From: J F [REDACTED]
Sent: Sunday, August 27, 2023 10:32 PM
To: TRANSPORTINFRASTRUCTURE <TRANSPORTINFRASTRUCTURE@dft.gov.uk>
Subject: Network Rail (Leeds to Micklefield Enhancements) Transport and Works Act Order

Objection to tree felling near Crossgates

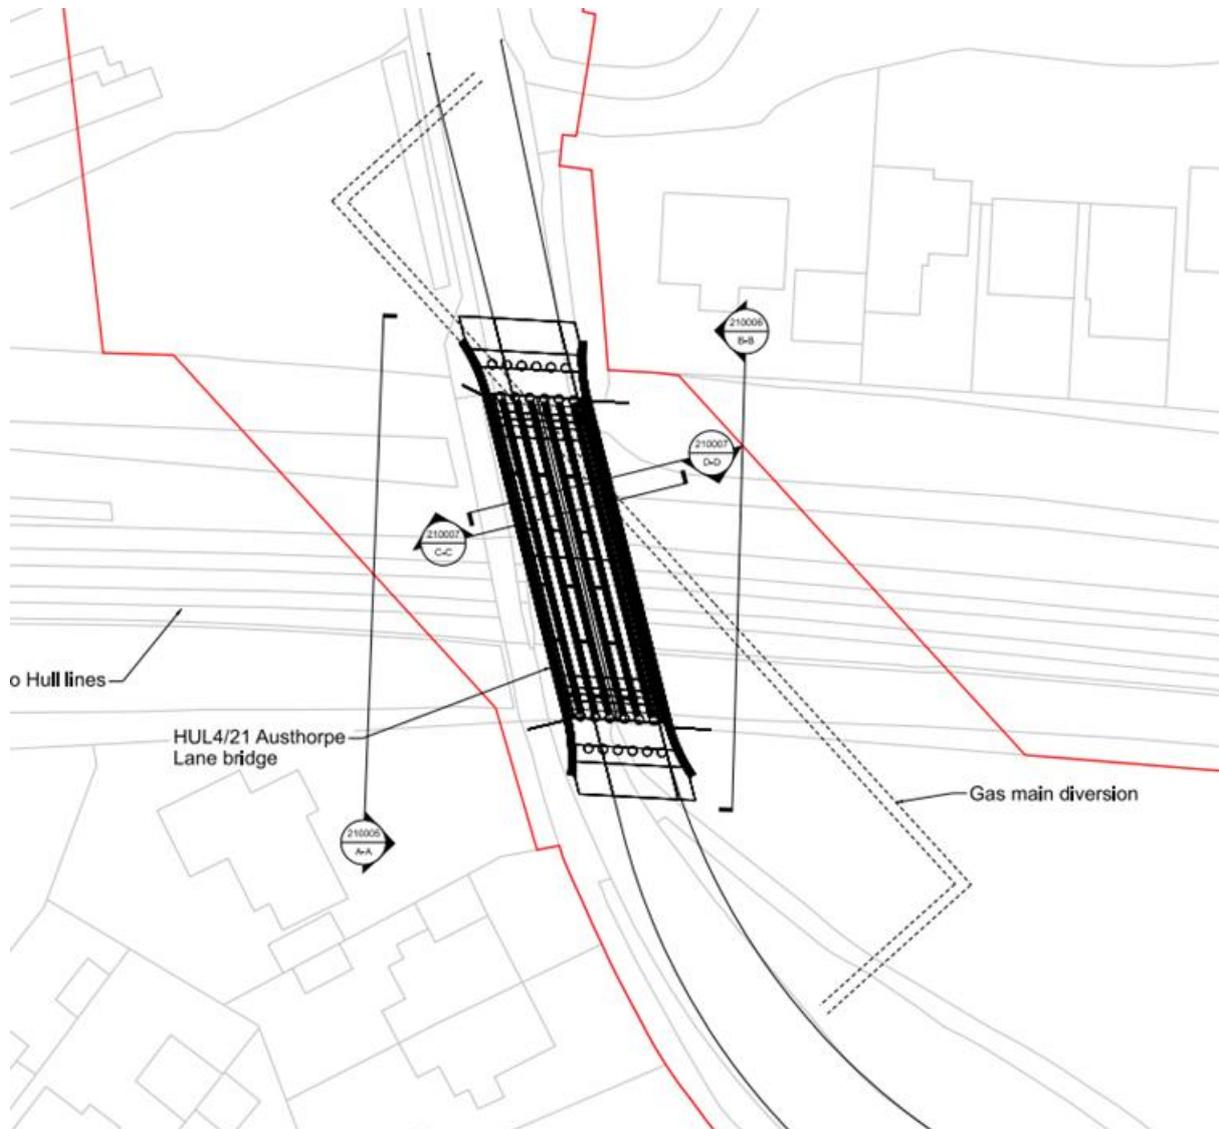
While I understand the need for infrastructure development, I firmly believe that the unnecessary destruction of our community woodland for the construction of a gas main diversion pipeline is an unjustifiable compromise. There are numerous alternative routes and methods that could be explored, ones that do not involve the destruction of a vital natural space. The negative impact of such a project on our environment, biodiversity, and the mental and physical well-being of our community members cannot be overlooked. Additionally the gas main visible over the active railway line can also be seen on the former Weatherby line shown on drawings 151666-TRA-00-HUL4-DRG-R-SG-310001 and 151666-TRA-00-HUL4-DRG-R-SG-310002 if the removal of

the whole woodland is required to lower it to a safe depth under the railway it will be too shallow to pass under Austhorpe Road and attach to the existing pipe adjacent to the farmstead.

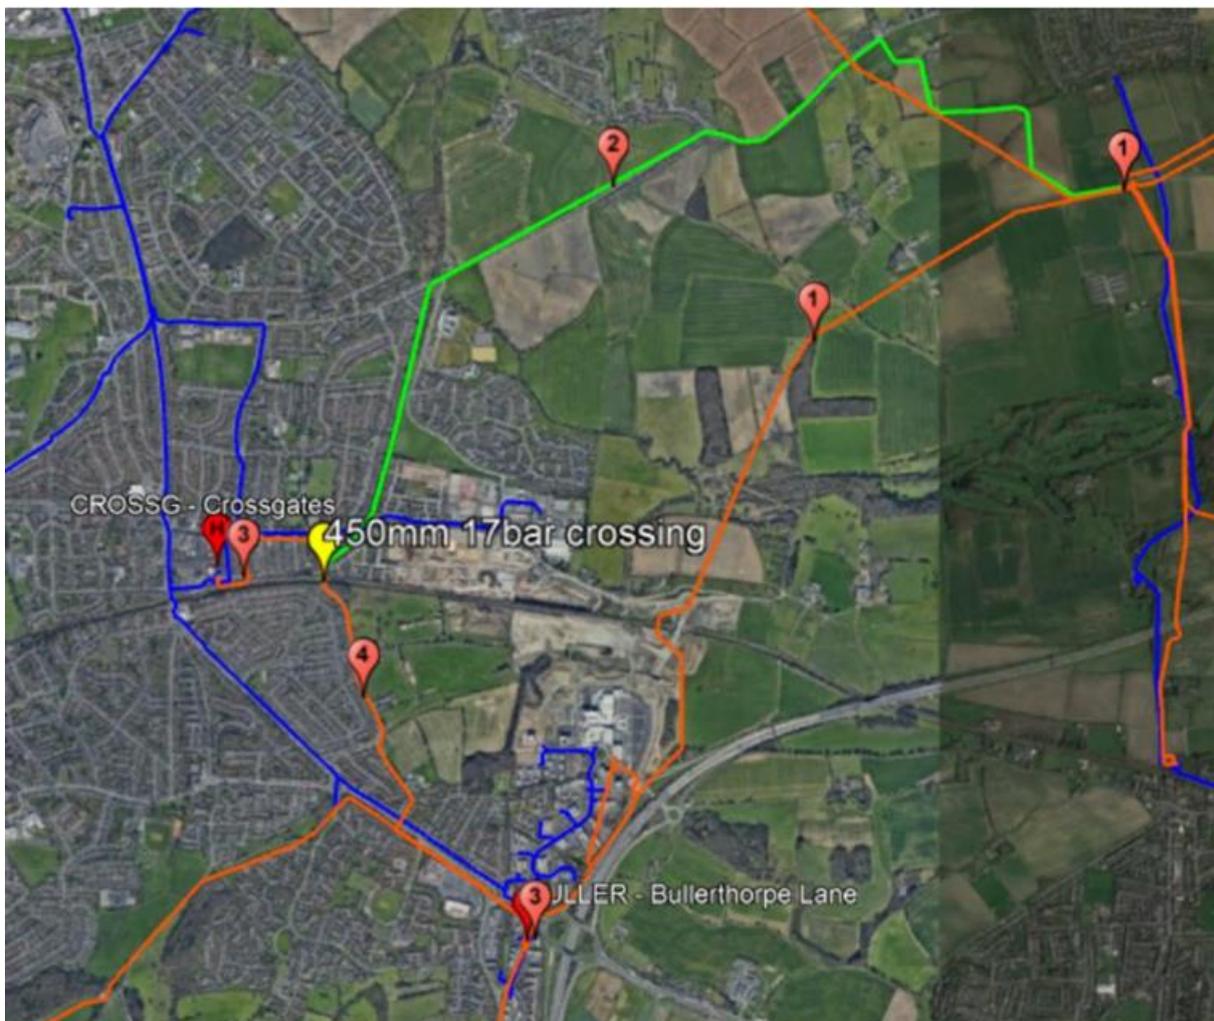
A gas Diversion via Manston Lane, under the railway by the moon ponds then back through the woodland would cost £9.8m, but the preferred option is to spend £9.7m reconfiguring the network by installing a new pressure reduction station (PRS) by chopping down trees in this residential area, and decommissioning the two PRS at Crossgates & Bullerthorpe Lane.

option 3. Downrating of 38bar into Leeds (1) removes the needs for Bullerthorpe Lane PRS, this site can be decommissioned and removed (3). IP reinforcement into Crossgate (2) removes the need for Crossgates 19-2bar PRS, this site can be decommissioned and replaced with 6.9-2bar district governor.

An improved modification of this would be to keep line 1 (Bullerthorpe-Barnbow) with a new link pipe along Manston Lane to Crossgates, thus removing the need for pipeline (4) Austhorpe Lane and railway crossing creating flexibility for the location of a new PRS including keeping one PRS location at Crossgates/Bullerthorpe and decommissioning the other, or keeping the current layout.

The pipe should also be perpendicular to the railway, a better alignment would be directly under the adopted highway(at Austhorpe Lane or William Parkin Way) and not via the private woodland. I believe this would also be a low cost as it's just the construction of a new 1.58 km large diversion pipe, nearly half of the discounted proposal for a 3km via private land.

HIGHWAYS TO BE PERMANENTLY STOPPED UP	
AUSTHORPE LANE AND AUSTHORPE ROAD	BETWEEN POINTS P1 AND P2

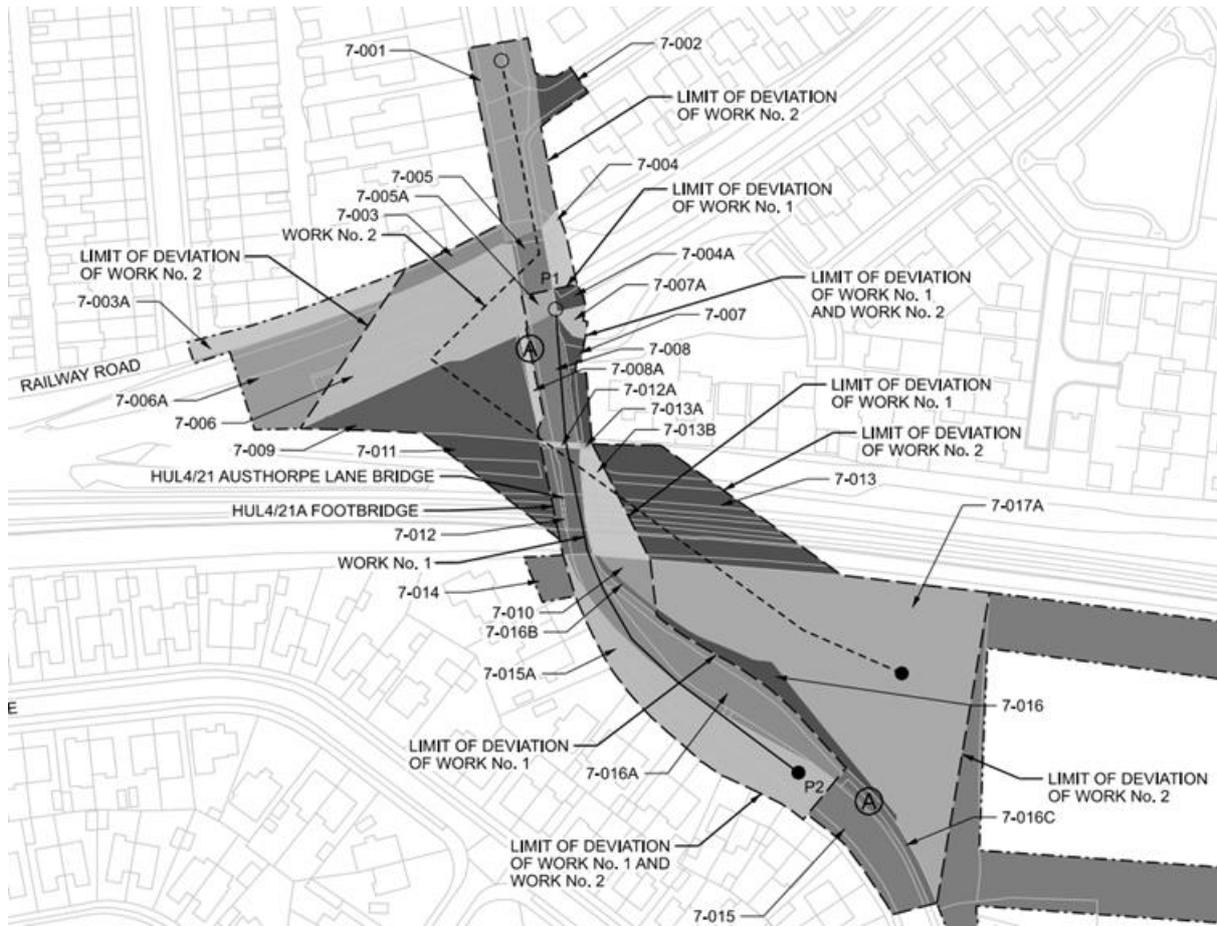
The proposed replacement Railway bridge here is a similar width to the existing narrow hump bridge, I believe a 5.5m carriageway with a 0.5m buffer to one side and a 2m footway at the other is dangerous as hostile/errant vehicles can mount the pavement, hit pedestrians or the bridge parapet. The kerbs should be a minimum of 300mm high to prevent this.

On the Crossgates side, the existing ~1m high pedestrian guardrail allows an unobstructed view of the railway and approaching trains for all people, Replacing this with 1.8m wall may lead to people attempting to climb over/onto it to view trains, last time we were there on the evening of the 9th July to see the flying Scotsman they were approximately 30 other people including children.

Drawing 151666-TRA-00-HUL4-DRG-R-SG-110004 states the road from P1 (south of Wetherby bridge deck)-P2(173 Austhorpe Lane) will be permanently stopped-up, this means the new road and bridge will be a privately owned public road maintainable at Network Rail (or other) expense, as their maintenance budget and safety-critical staff resource

is being reduced I imagine they would want to enter a section 38 agreement to transfer ownership (and maintenance) to Leeds City Council, however, this can not happen as this does not meet any adoptable standard (one is a minimum of 3m shared-use foot & cycle path throughout the new development, in this case connecting the new path out of the Limes, over the railway). Crossgates station used to have a footbridge, but this was left to rot into a dangerous condition and then demolished by the railway authority I fear the same fate for this bridge. The existing footbridge was added as the footpath across the existing road bridge was not considered safe for pedestrians, to reinstate this footpath considering the increased number of vehicles using the bridge would be a foolhardy and unnecessary risk to pedestrians.

The existing Narrow/Weak bridge has a 7.5t weight ban this acts as traffic-claiming and prevents large vehicles from running through the Deven estate any improvement to this road would induce more demand and increase trips in the residential area. I would like proper community engagement to consider and poll multiple options including traffic lights, one-way street, buses and emergency access only, and pedestrianisation
